Stonestreet Green Solar Responses to Deadline 3 Submissions

Doc Ref. 8.13

Deadline 4

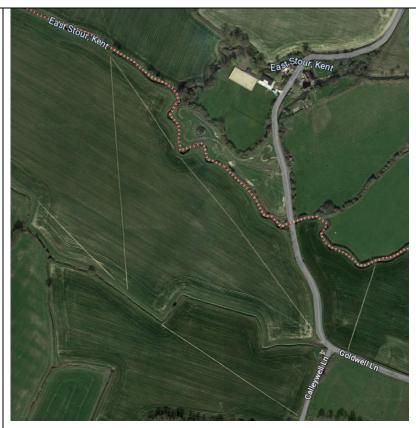
AE447 currently links AE 378 with AE448 and, as such, can and does provide the possibility of circular walks for eg dog walkers in the area. North East of AE448, older maps show that the path once continued across footbridges to Evegate Mill.

These bridges, however, no longer exist, so the path to Evegate Mill no longer exists. This portion of AE447, therefore, is - de facto - no longer of use, unless the footbridges were to be re-instated and the former route added to the Definitive Map.

AE 447 is an existing short link that runs diagonally across Field 19 linking AE 378 to AE 448. It continues past AE 448 north-easterly to a 'dead end' at the river, where the statutory extent of the PRoW as set out in the Definitive Map ends (as noted, there is no river crossing or path continuation, and no link to the motorised highway).

Given the availability of alternatives (via AE 378, AE 448 diversions and New 7 / FN-7) this extinguishment is in compliance with Section 136 of the Planning Act 2008, and it is noted that the section that continues past AE 448 is a 'dead end' i.e. does not connect to the rest of the highway network (PRoW or motorised).

Alternatives will be available via AE 378, AE 448 diversions and New 7 / FN-7 (as referenced in the **Draft DCO** (**Doc Ref. 3.1(E)**), the **Streets, Rights of Way and Access Plans** (**Doc Ref. 2.5**) [APP-011] and **ES Volume 3, Figure 3.2**: **Proposed Access Network** (**Doc Ref. 5.3**)) [APP-045].
